**ADDENDUM NO. 2
TO CONTRACT DOCUMENT PLANS SPECIFICATIONS**

**PROJECT: MWA METRO PARK WEST LANDFILL
P-67 CELL E LINER, LEACHATE LAGOON, AND SED POND**
TO: PROSPECTIVE BIDDERS AND OTHER INTERESTED PARTIES

SHEET C508

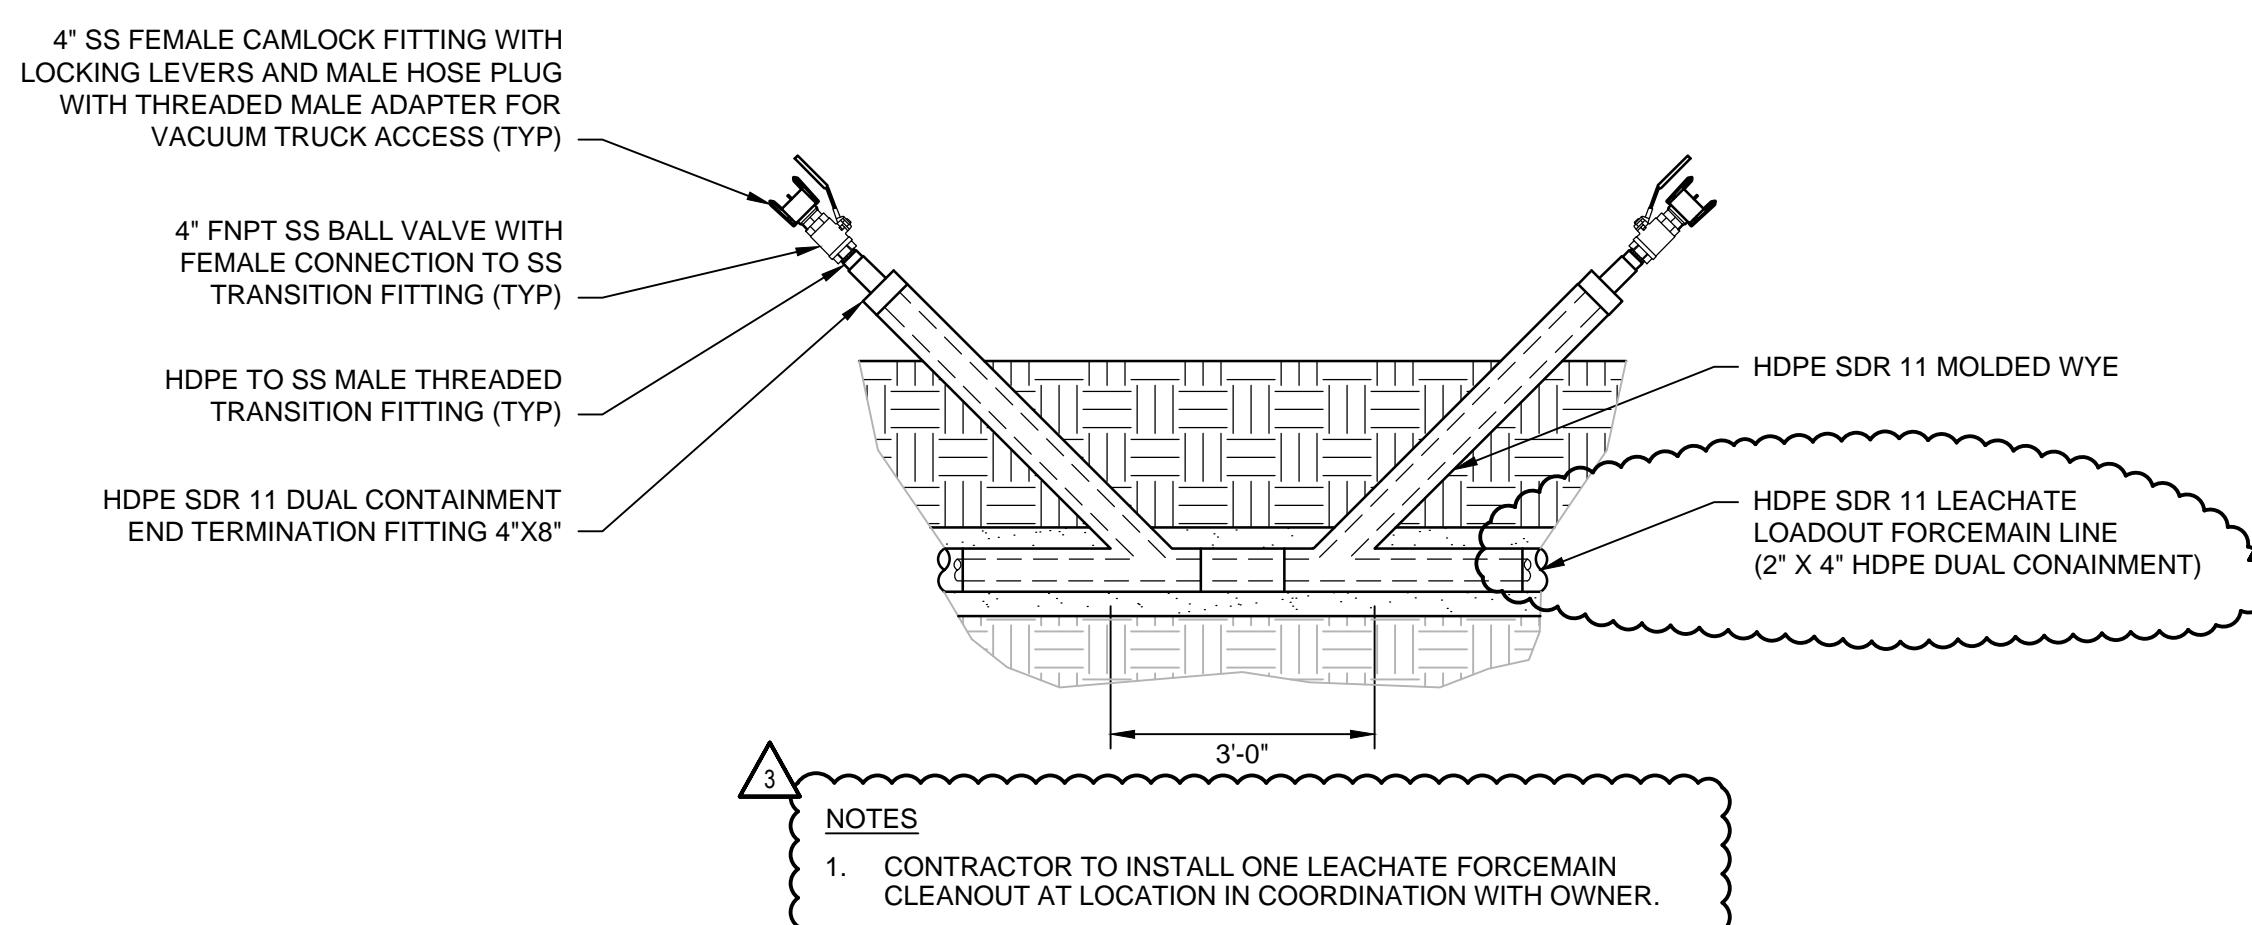
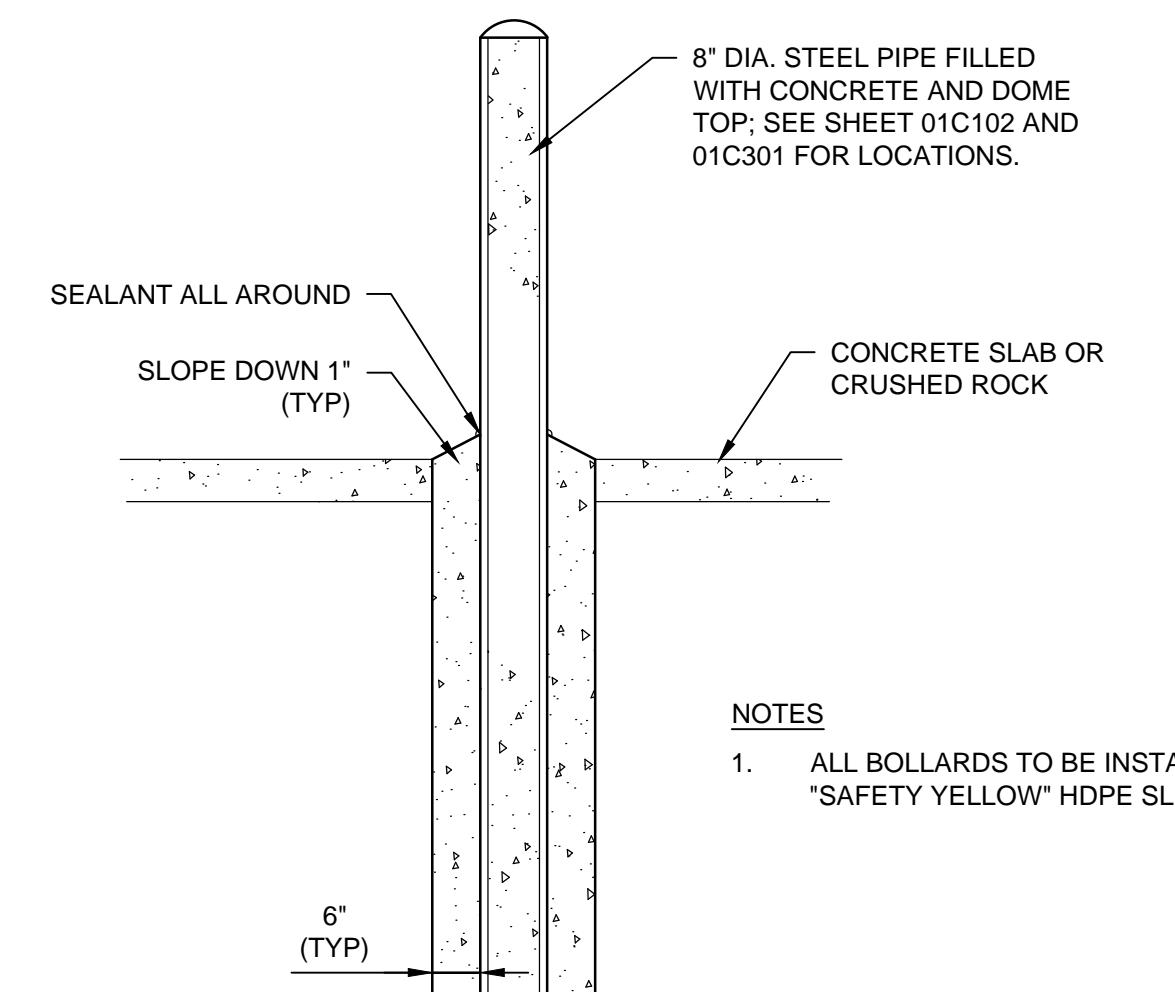
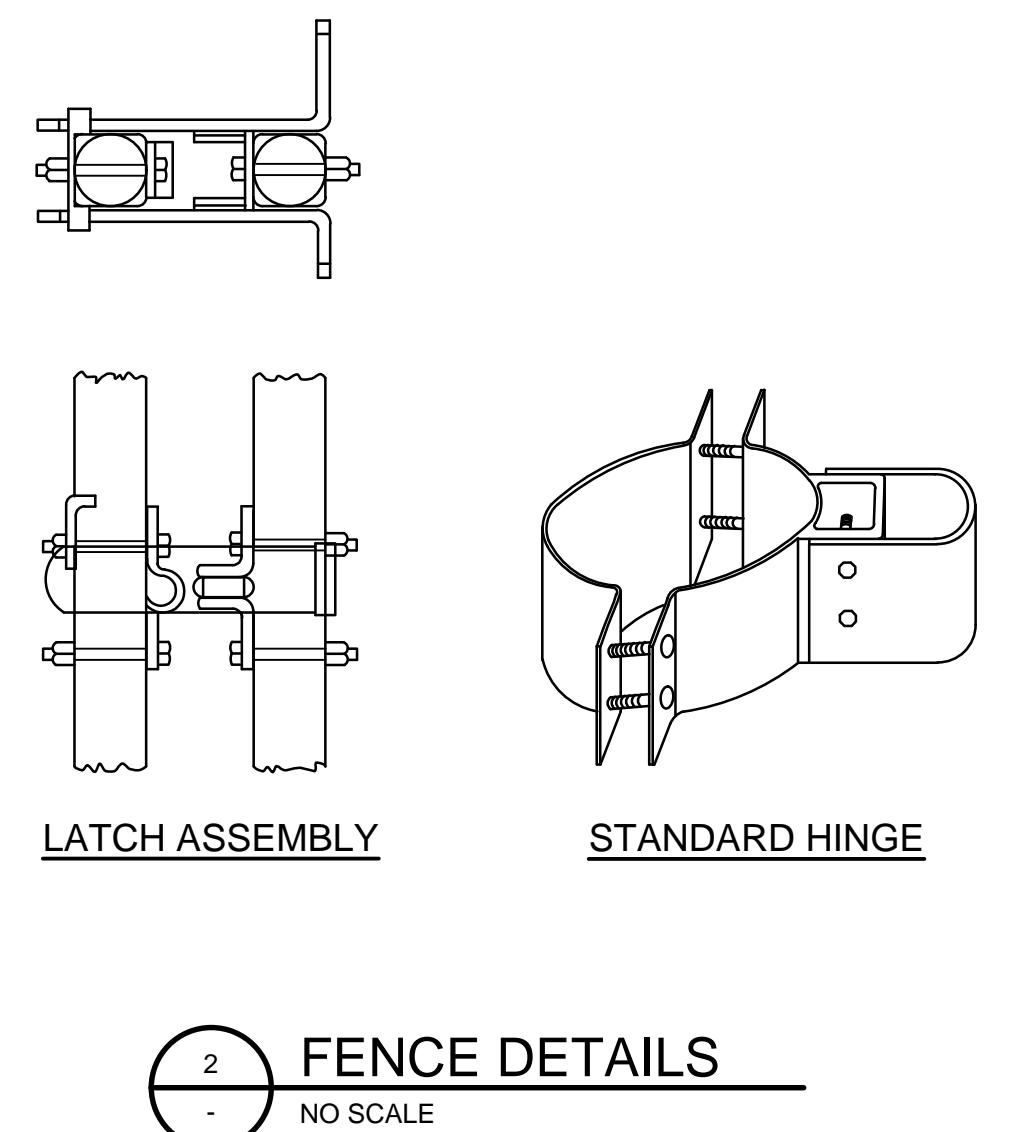
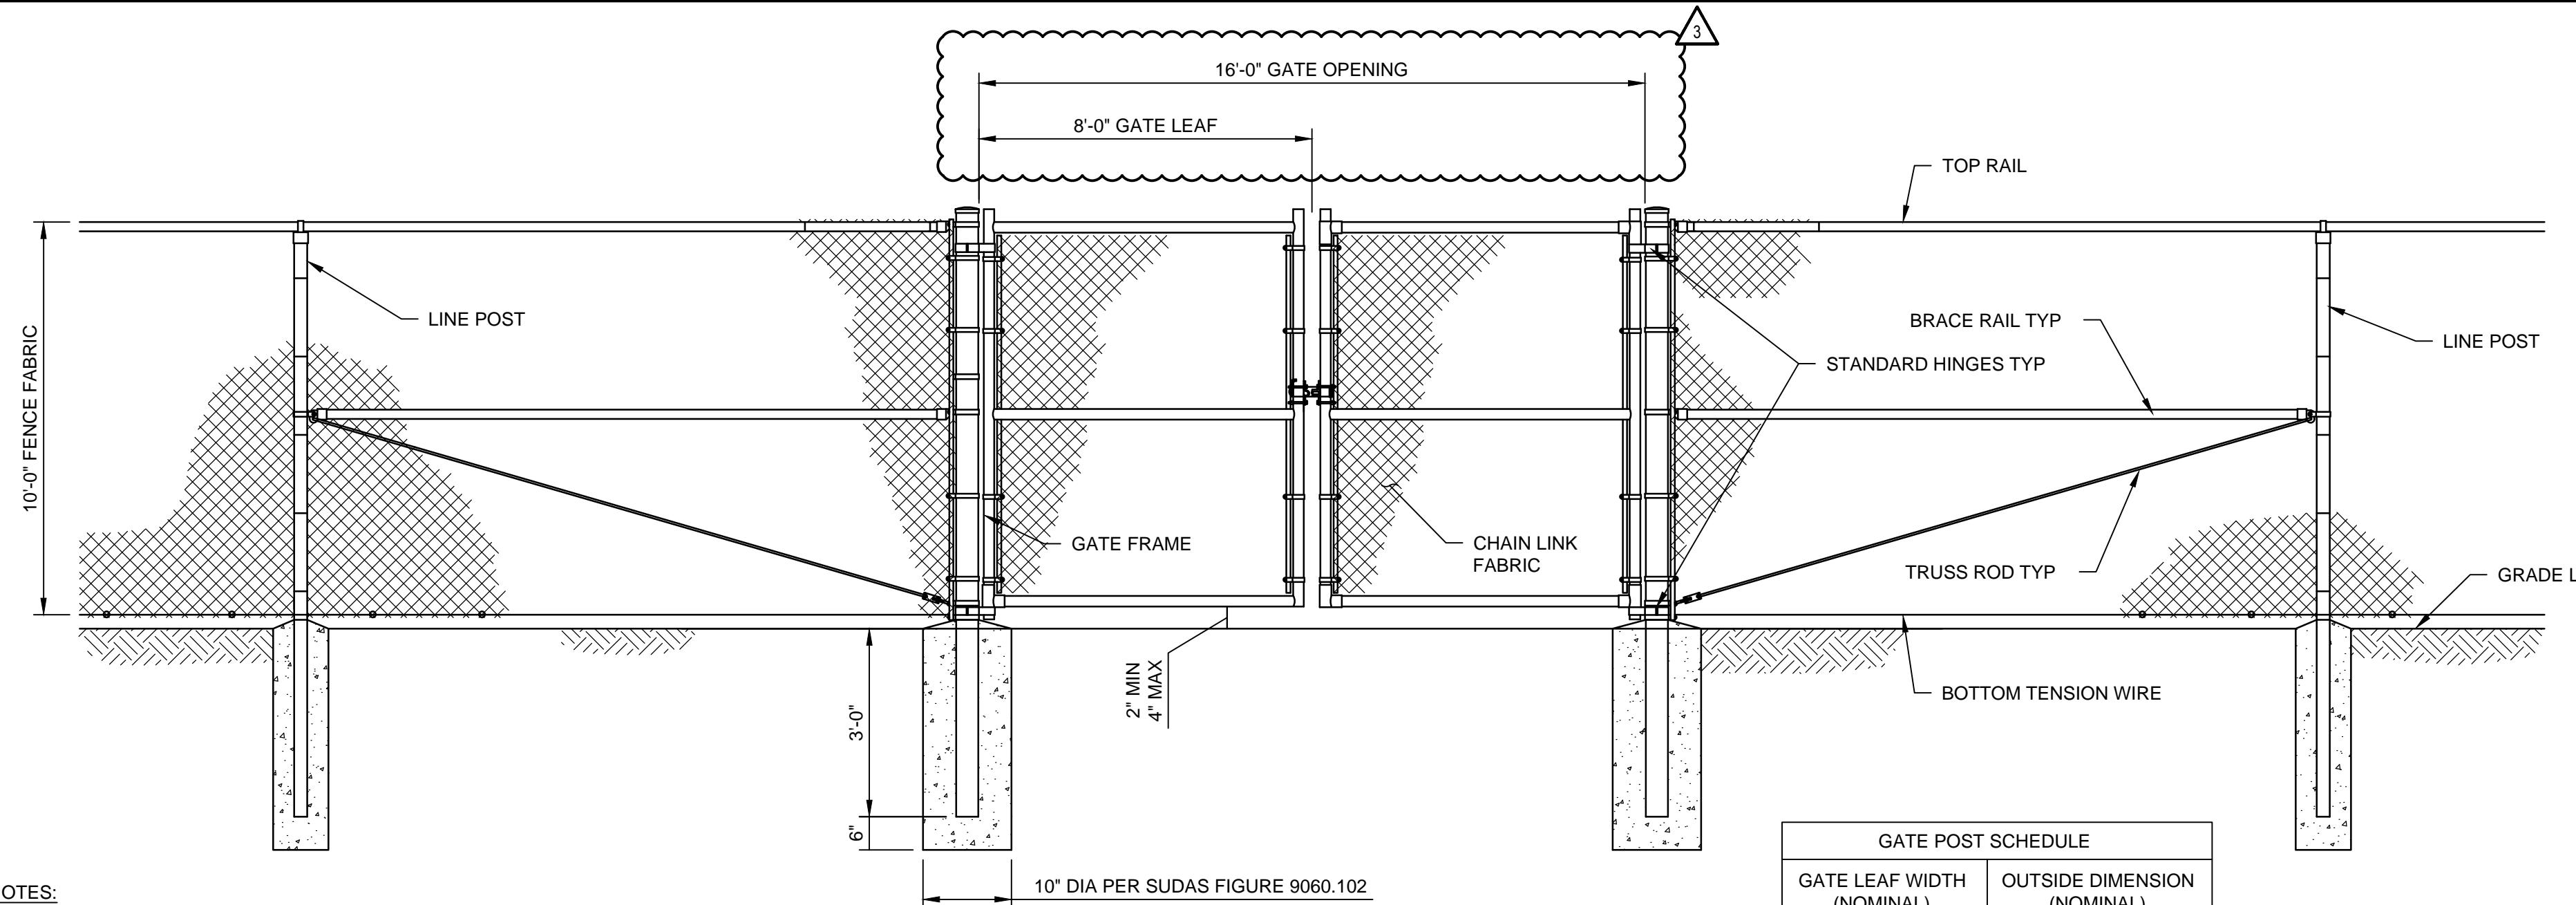
Question 26: On sheet C508, detail 1 calls out of 4 EA 2'-0" DIA CONCRETE BOLLARD, TYP and detail 4 is for 8" steel bollard. Can you confirm which bollards you would like installed and provide additional details (depth of bollard, height bollard is to extend above grade, etc...)?

Question 27: On sheet C508, detail 1 calls out for a 6" raised concrete pad with sealed expansion joint between the leachate loadout pad and the leachate pipe with a panel and pump. Can you please provide a detail on this concrete pad? Can you also provide reinforcement details on detail 2 for the containment pad?

Answer 26: Bollards shall be 8" diameter per Detail 4 on Sheet C508. Detail 1 on Sheet C501 has been revised.

Answer 27: Concrete pad is 8" in thickness, see Detail 2 on Sheet C508 of Addendum #2.
